**Re: 08RFP60817K-DB
Design Services for T040 Cochran Mill Road Over Pea Creek, Bridge
Replacement**

Addendum No. 1

Addendum No. 1

**Design Services for T040 Cochran Mill Road Over Pea Creek, Bridge
Replacement
Addendum No. 2
Page 4 of 4**

REVISION DATES
 STATE OF GEORGIA
 DEPARTMENT OF TRANSPORTATION
 OFFICE DISTRICT 7
DAVIDE FUM & PROFILE
 COCHRAN MILL RD @ PEA CREEK
 BRIDGE REPLACEMENT
 SHEET NO. 13872/COCKBURN MIL. ROAD

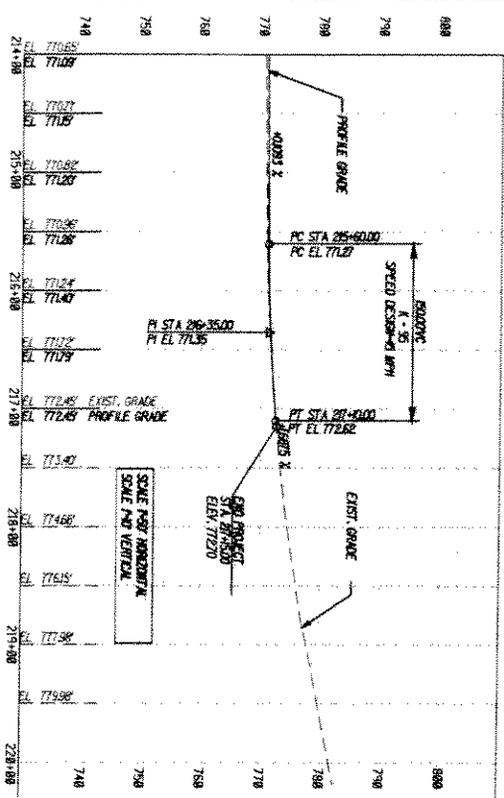
4. **QUESTION:** The RFP states that the concept report, preliminary plans, and a preliminary field plan review have been held for this project, please confirm if this is indeed correct. If so, can the preliminary design plan sheets (only plan sheets, not profiles or cross sections) be placed as an addendum for viewing?

RESPONSE: It is correct. Profile and plan view will be posted for reference only. See cost proposal form for additional reference.
